**MINUTES
BOARD OF BUILDING STANDARDS/
ARCHITECTURAL BOARD OF REVIEW/SIGN REVIEW
REVIEW MEETING
CITY OF LAKEWOOD
12650 DETROIT AVENUE
AUDITORIUM
JULY 13 2023
5:30 P.M.
RECORDED
<https://www.lakewoodoh.gov/videos-2/>**

July 2023

Docket No. 07-63-23 (1639 Alameda)

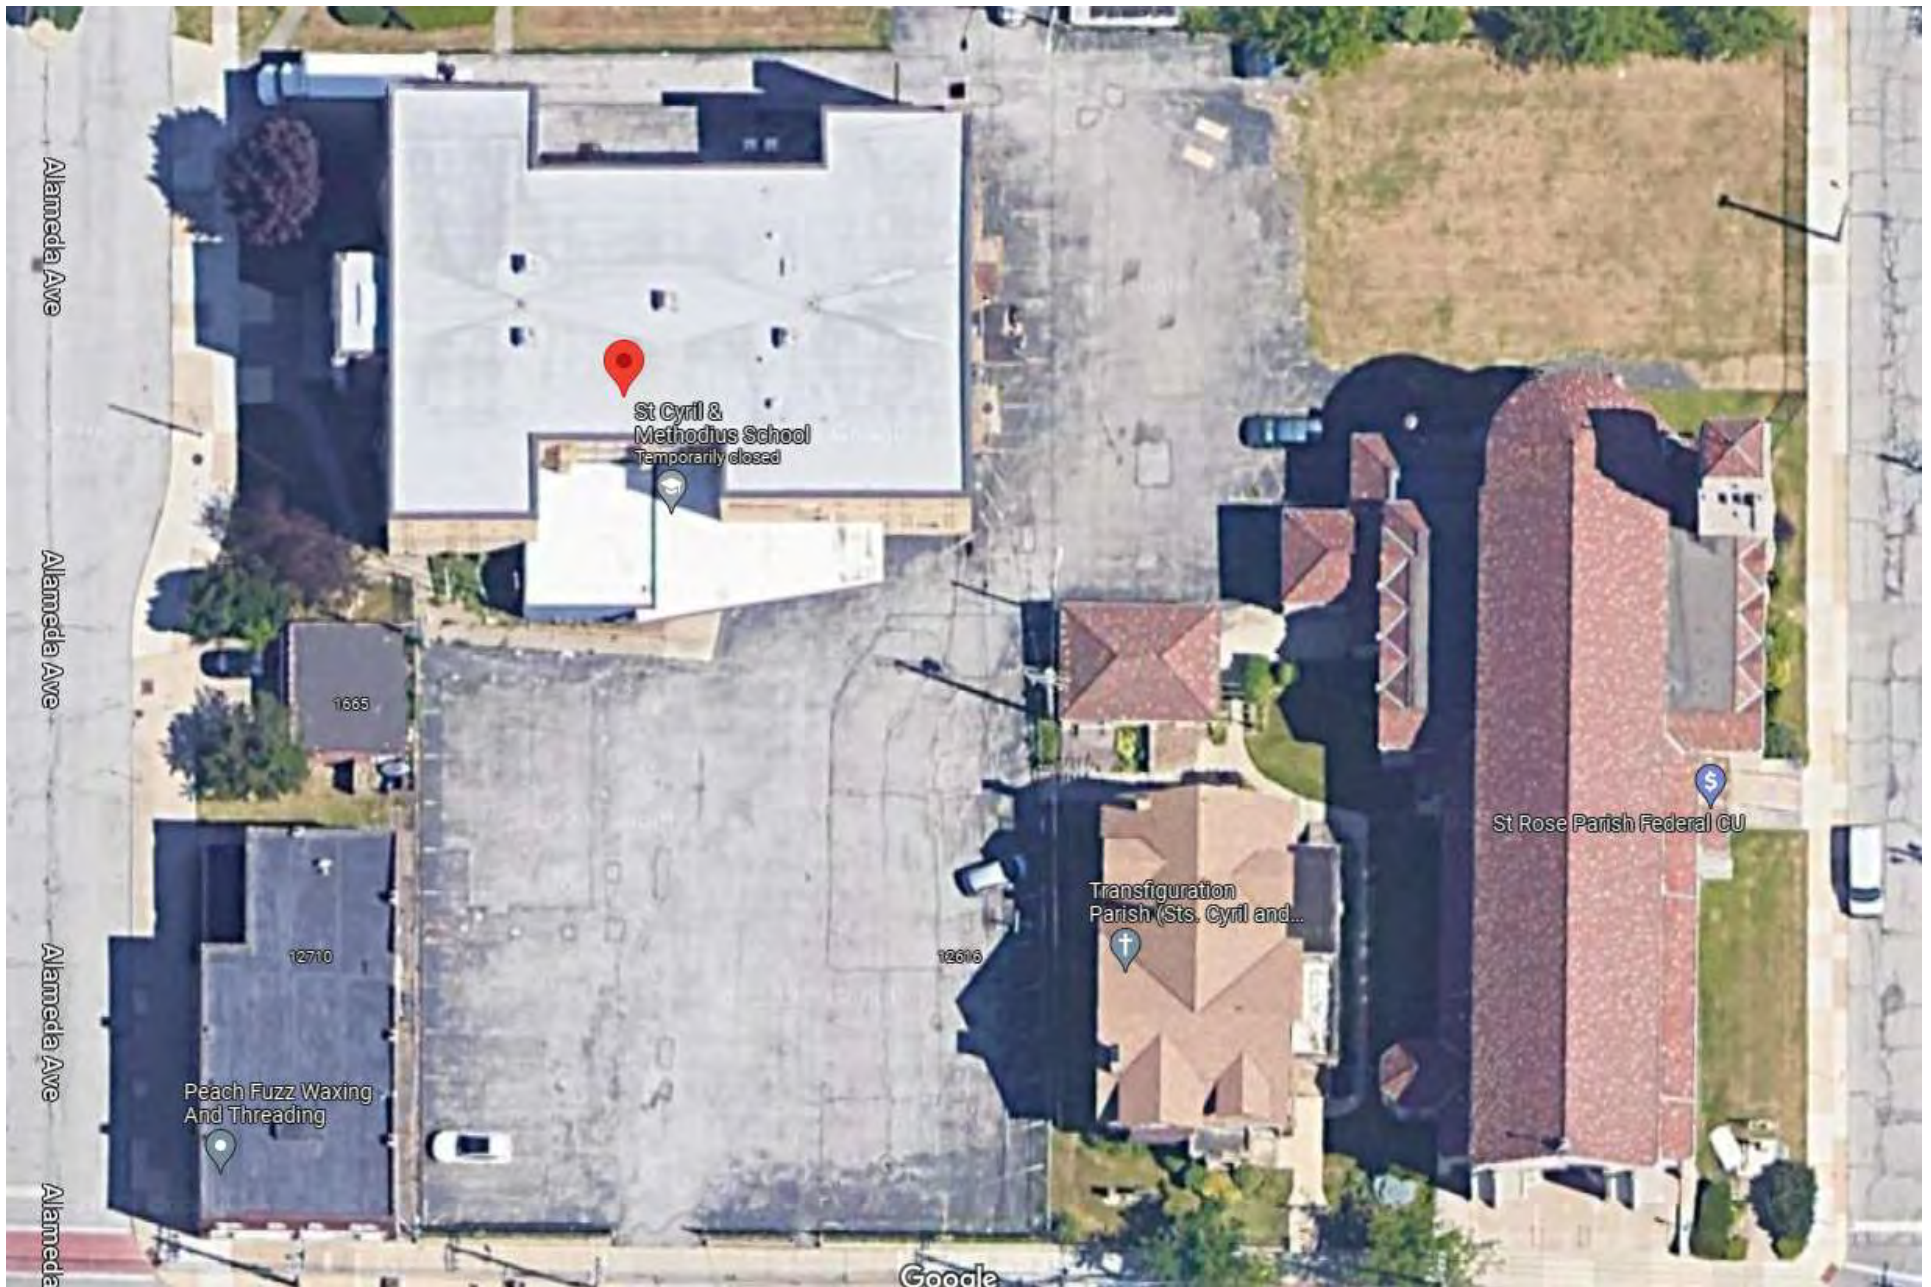
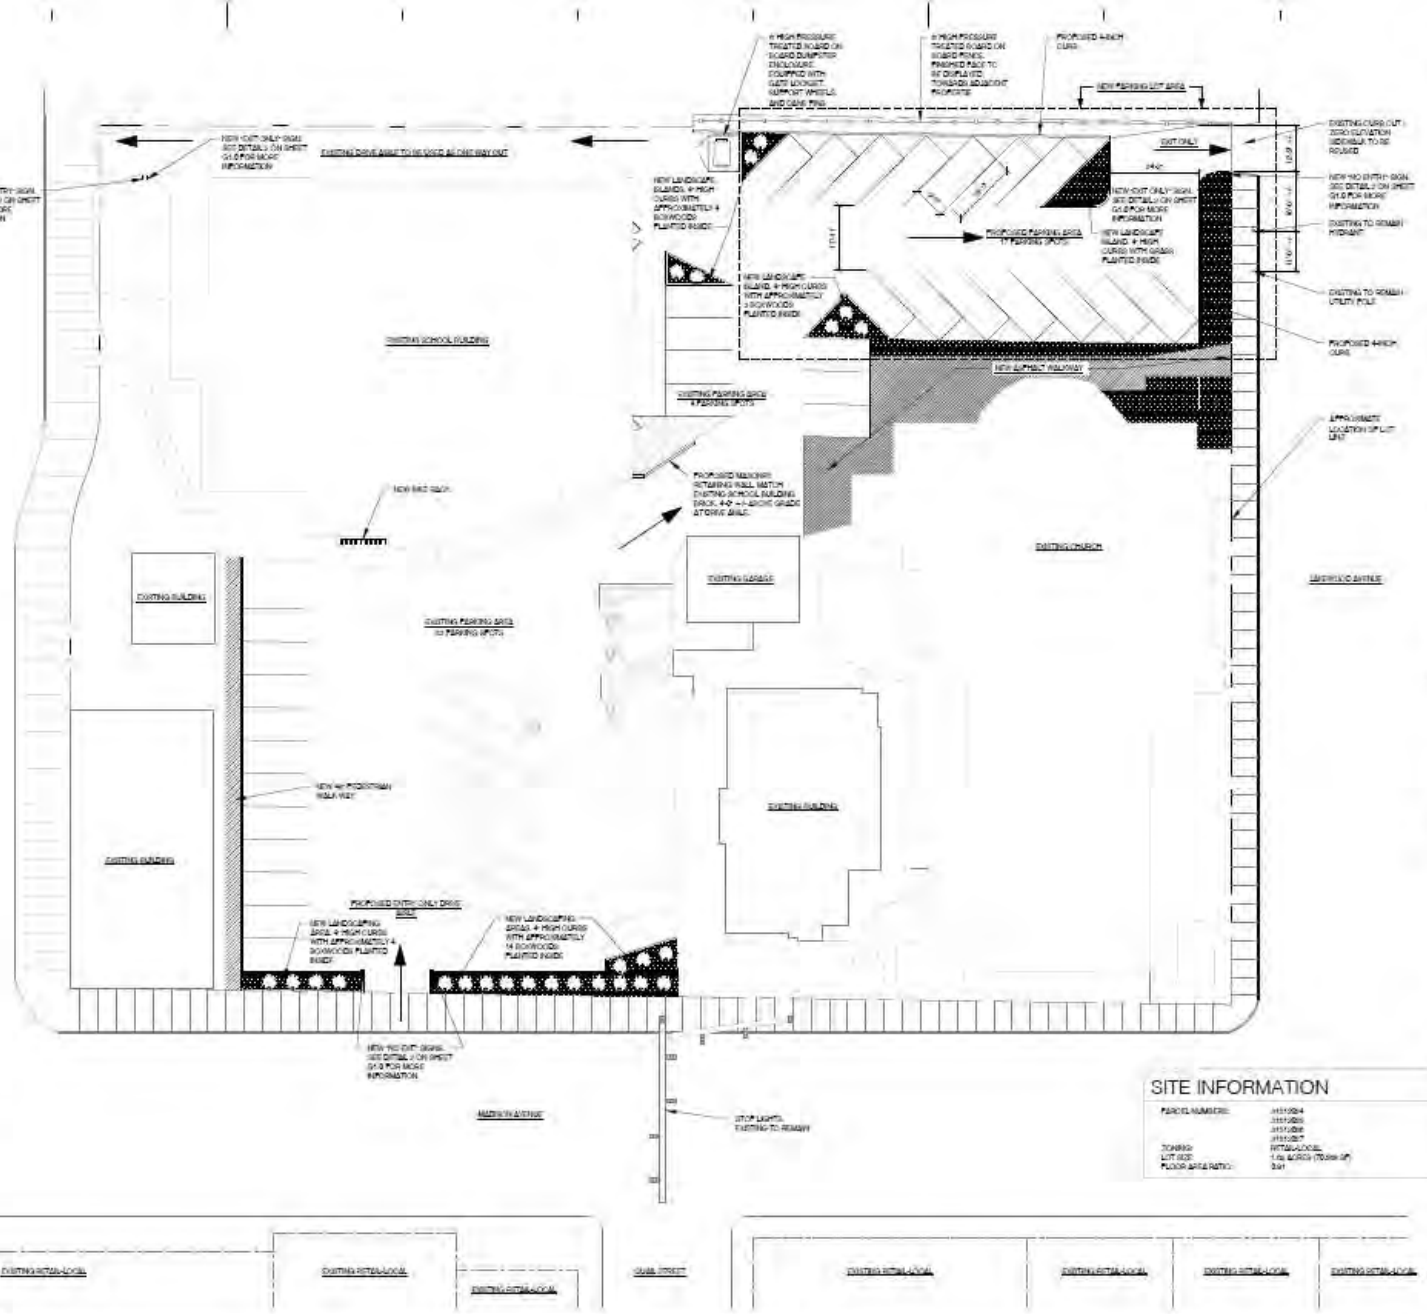
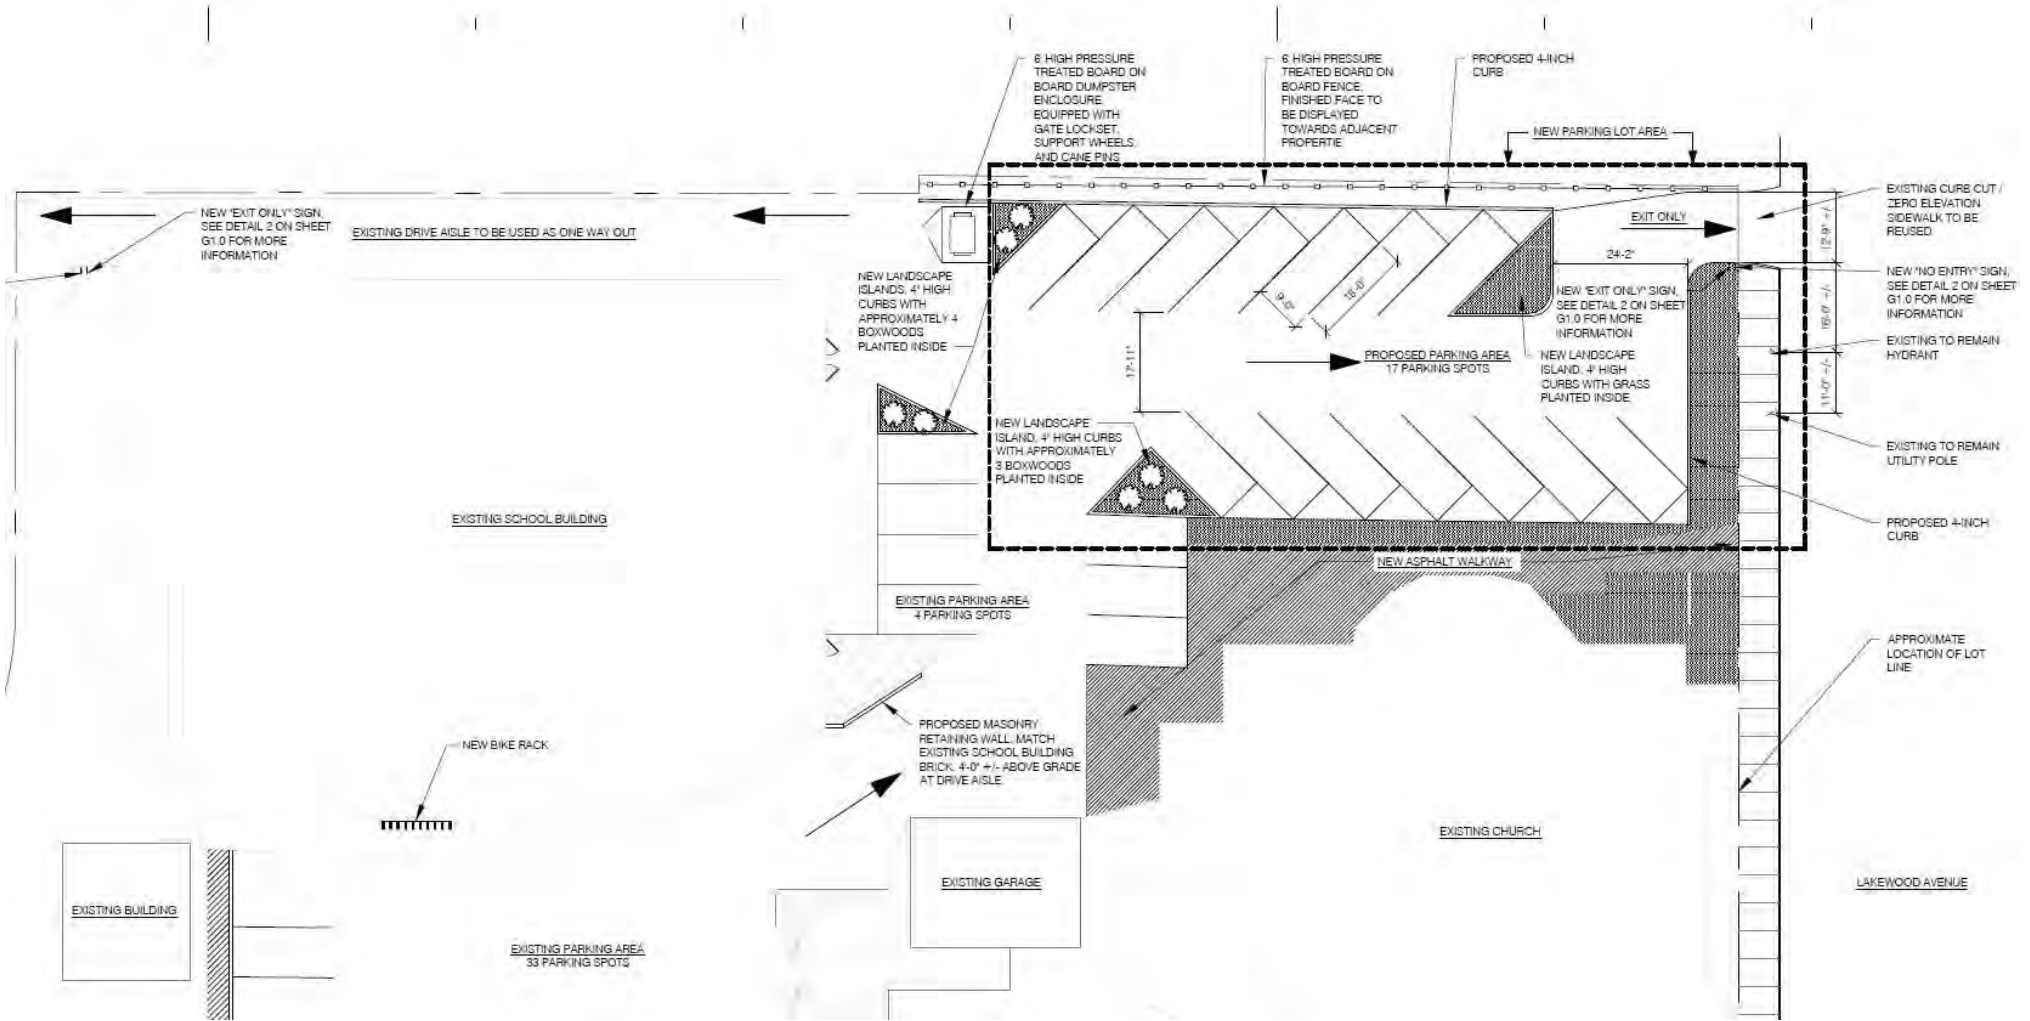
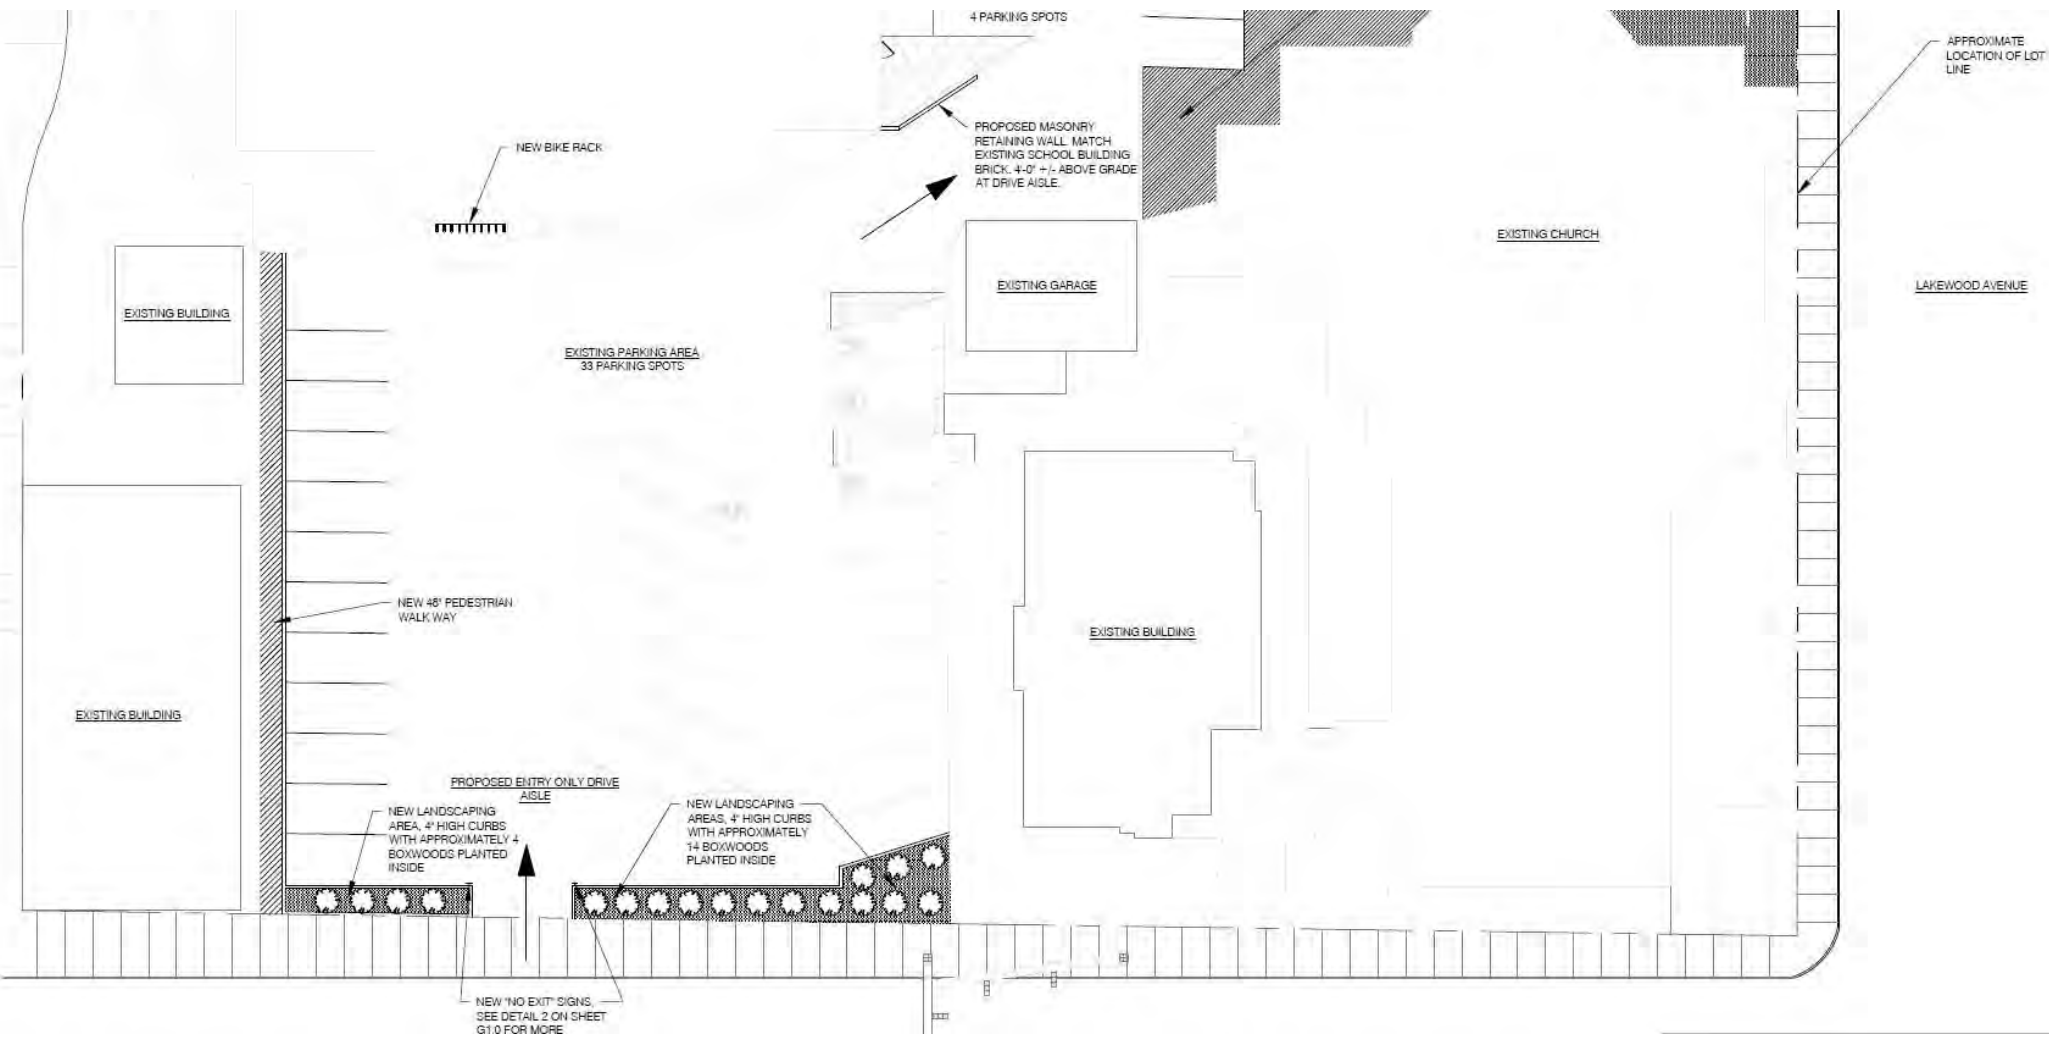
James Miketo, Neighborhood Drummer LLC, applicant was present to explain the request. Discussion commenced about access of the public through the property, there would be no additional lighting, the board-on-board design fence along the north side of the property and its graduated heights, whether Engineering needed to be involved. Staff had no additional comments. Staff did not receive any communication prior to the meeting. Public comment was closed as no one addressed the item.

- Provide material spec sheets
- Provide signage in plan
- Pedestrian connectivity

- **Fencing will match the city's fencing requirements and will be reviewed for administrative approval.**

Docket No. 07-64-23 (14538 Detroit)

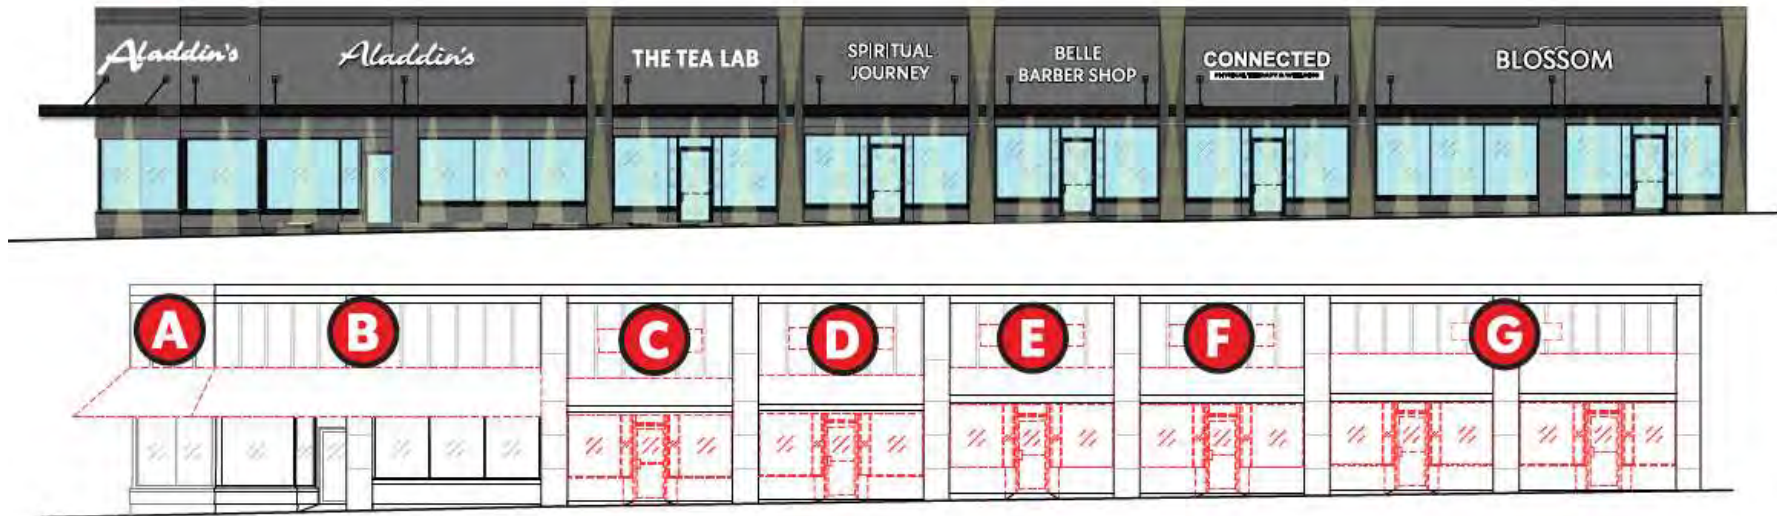
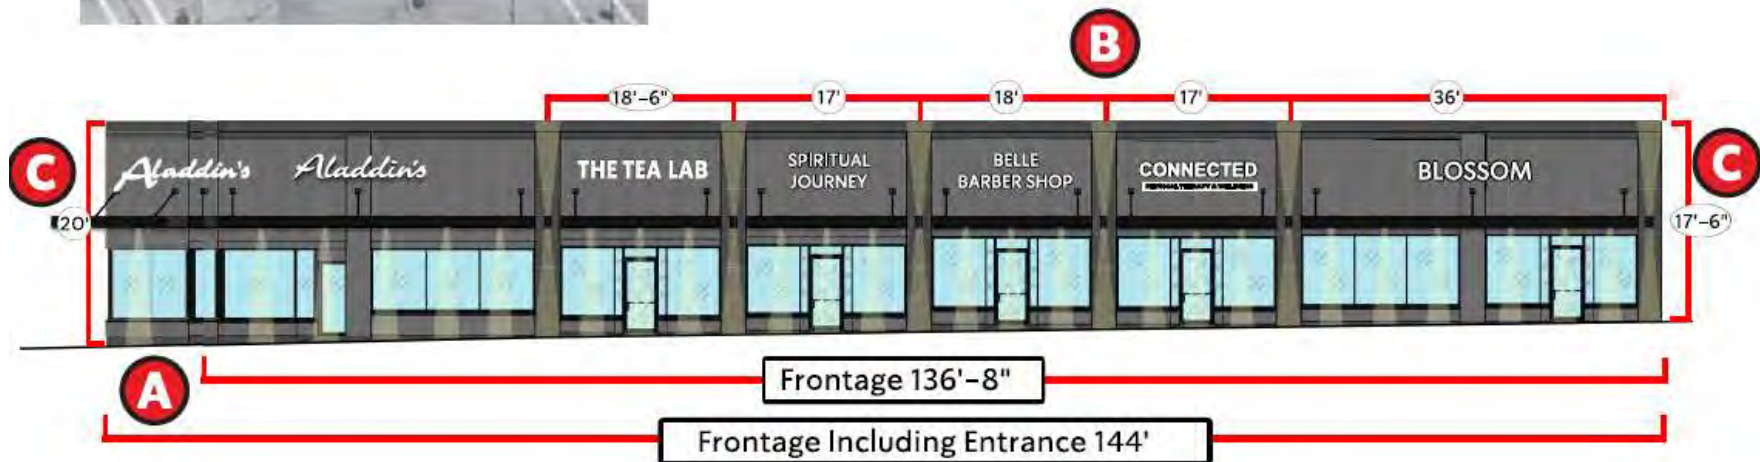
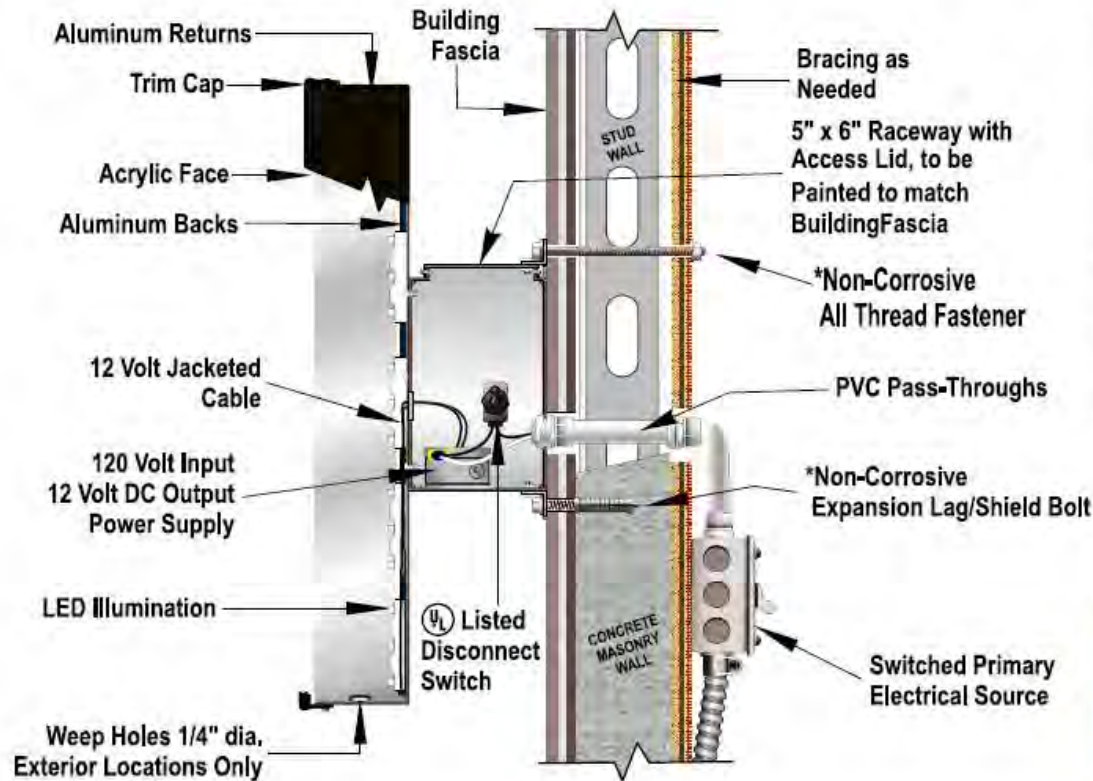
- Some conduit visible
- Clarify text style

- **Regarding the tenants' signage, submit updated proposal with a consistent font size for administrative approval.**
